**Subject: PETITION FOR INSIGNIFICANT PROJECT CHANGE FOR
ADDITIONAL SAFETY PLATFORMS AT MAGNOLIA POWER
PROJECT (01-AFC-6)**

**PETITION FOR INSIGNIFICANT PROJECT CHANGE
FOR
ADDITIONAL SAFETY PLATFORMS
AT
MAGNOLIA POWER PROJECT**

At Magnolia Power Project several areas have been identified where additional safety platforms are needed to improve operations and maintenance access to the process equipment. The areas are shown on the attached Site Plan (Drawing No. 010-G-002).

CONDENSER WATERBOX MANHOLE ACCESS-ELEVATION

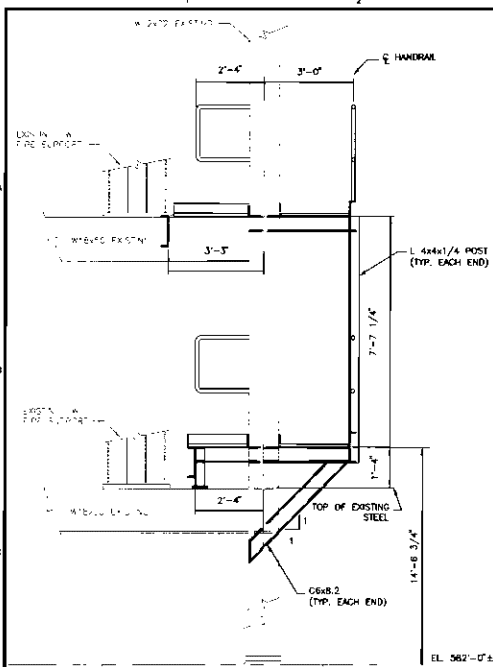
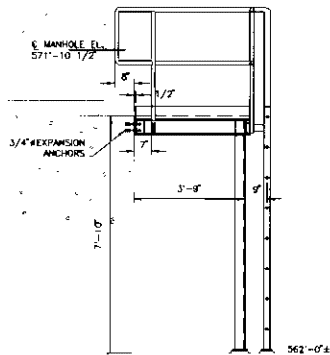
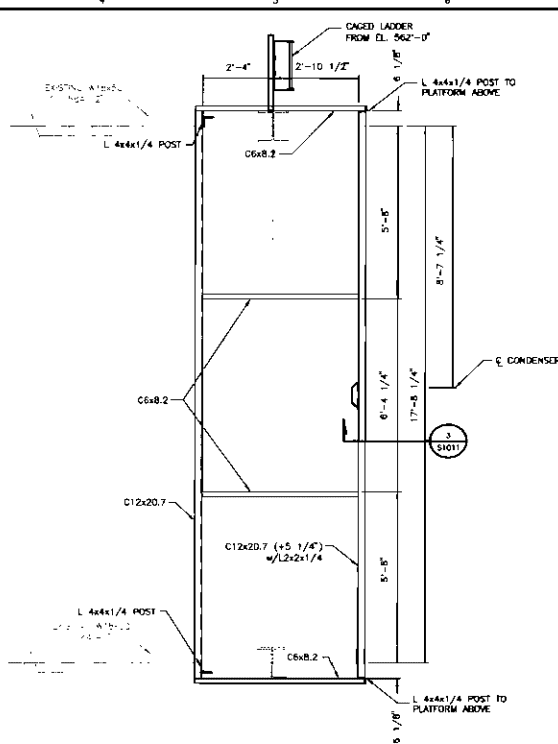
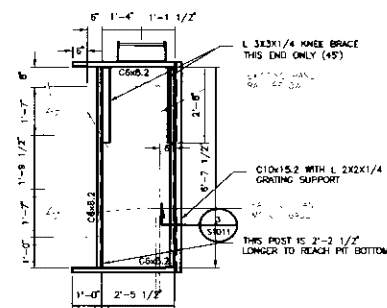
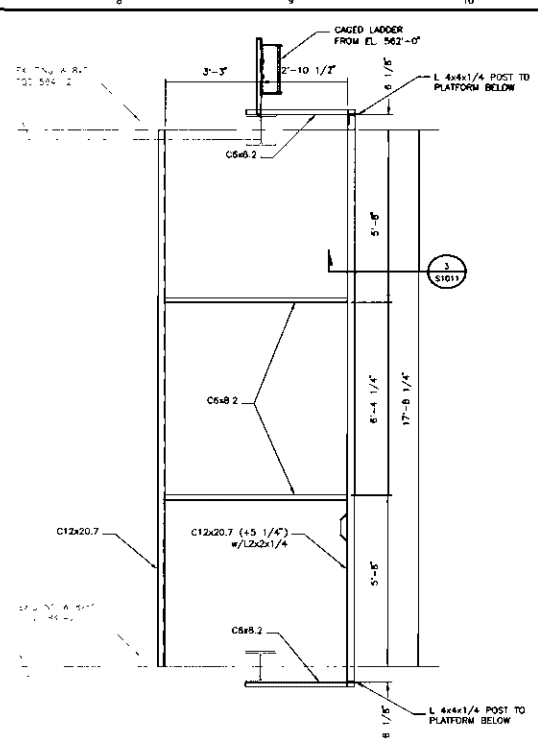
- Item 12. Platforms with ladders are needed to access manways on the south side of the Condenser. This multilevel platform is needed to facilitate inspection, brushing, and air lancing of the condenser tubes, as needed to maintain cleanliness on the circulating water side of the tubing inside the Condenser. This platform will be erected inside of the STG Building.

- Item 13. A small platform with a ladder is needed to access the blower motor control boxes above the Gland Steam Condenser. The control panel needs to be routinely accessed by operations personnel. This platform will be erected inside of the STG Building.

ZLD PLATFORM ACCESS PLAN

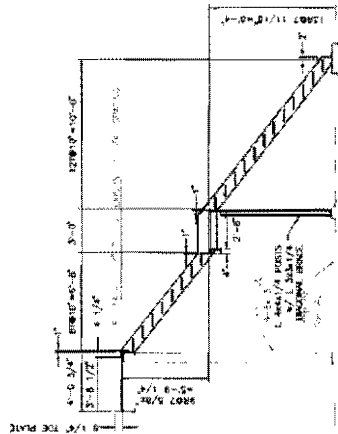
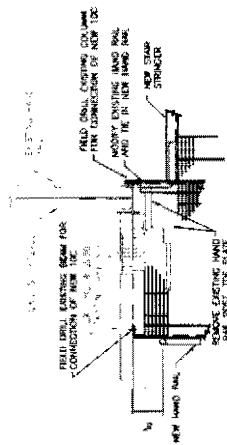
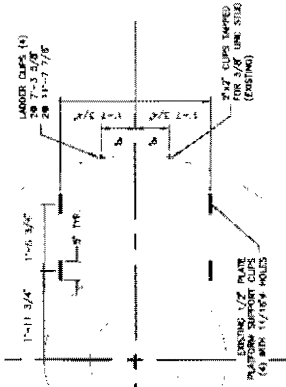
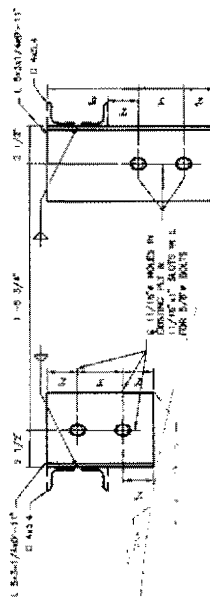
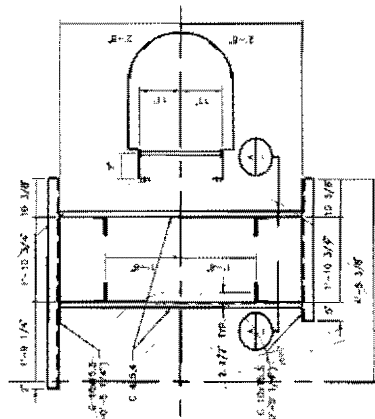
- Item 6. A stairway is proposed to replace an existing ladder on the northeast end of the platform accessing the forced circulation heat exchanger and belt press in the ZLD Area. Operators tend to this equipment multiple times per shift, so a stairway is appropriate

- Items 7 & 8. There are four vessels in the ZLD area (two Multi-Media Filters and two Weak Acid Cation Units) that require working platforms atop the vessels to change-out the media or resins inside the vessel beds. Although clips are provided for the attachment of ladders and platforms on these vessels, none were provided by the original equipment manufacturer. The frequency of changing the resins and media in these vessels necessitates addition of the working platforms.

Perspective View from Control Room

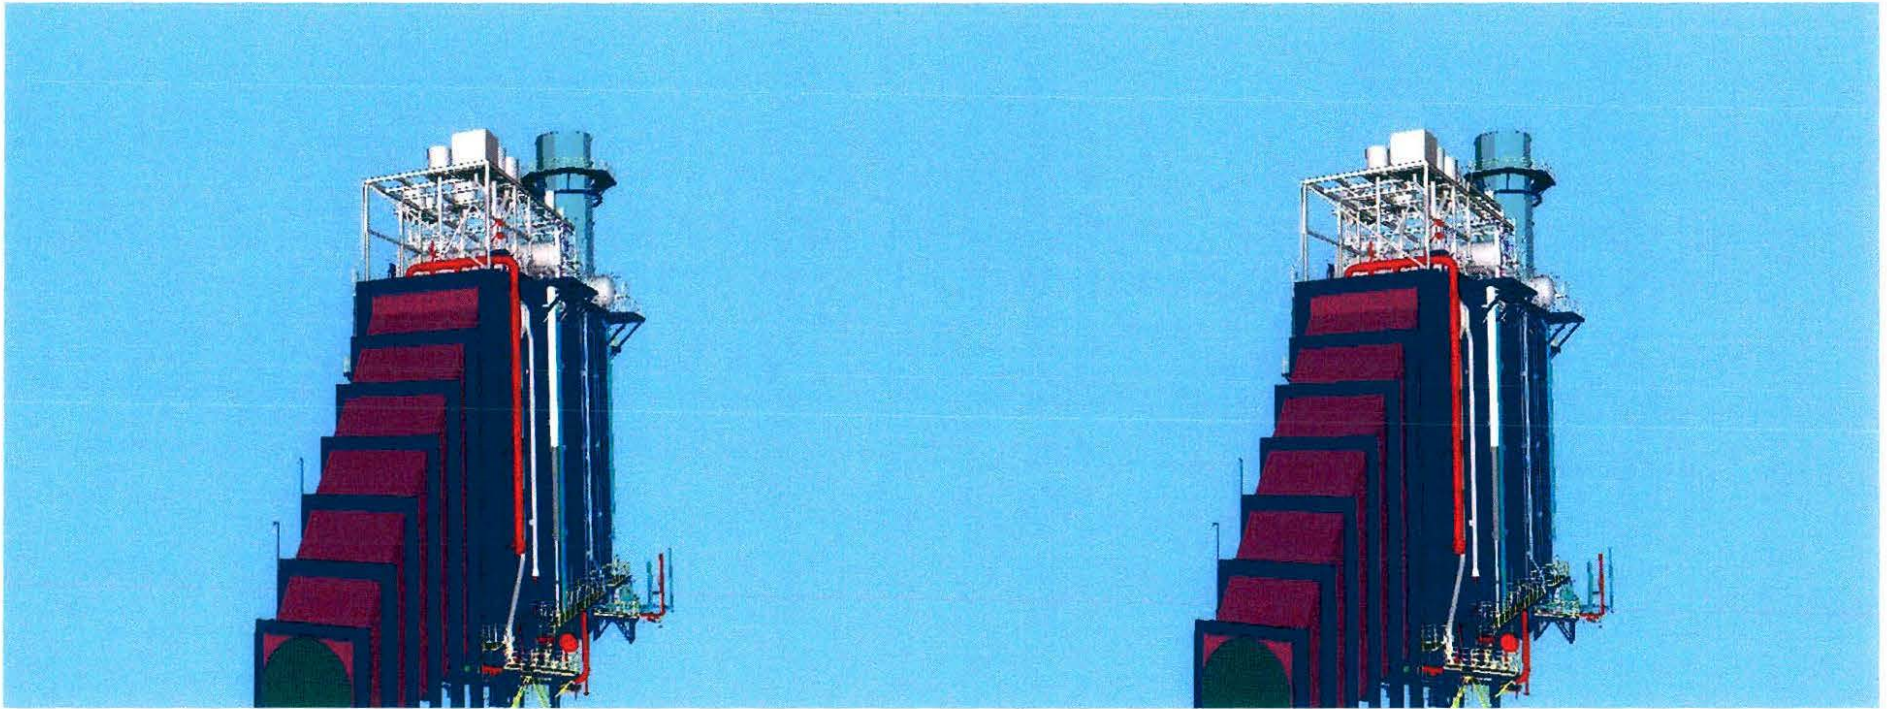
- Item 15. A platform with ladder is needed for access to inspect the silencers atop the HRSG. This platform will be installed above the silencer support structure, and will be equipped with a ladder lock to prevent uncontrolled access. This one is the only proposed platform to be installed where it could be visible from outside the plant area. To mitigate visual impact this platform will be galvanized like the silencers, with supporting members painted the same color as the existing silencer support structure.

The additional platforms proposed will have no significant adverse impacts on the environment. The only possible impact identified is the potential visual impact of the proposed Silencer Inspection Platform atop the HRSG (Item 15 above). To mitigate any significant adverse visual impact, the platform is set-back from the periphery of the structure and is located mostly behind the existing silencers. To blend-in, the platform will be galvanized (like the silencers), and the supporting structure will be painted the same color as the existing silencer supporting structure. In Appendix A four perspective views are modeled to illustrate the appearance of the top of the HRSG (before and after the silencer inspection platform is added).
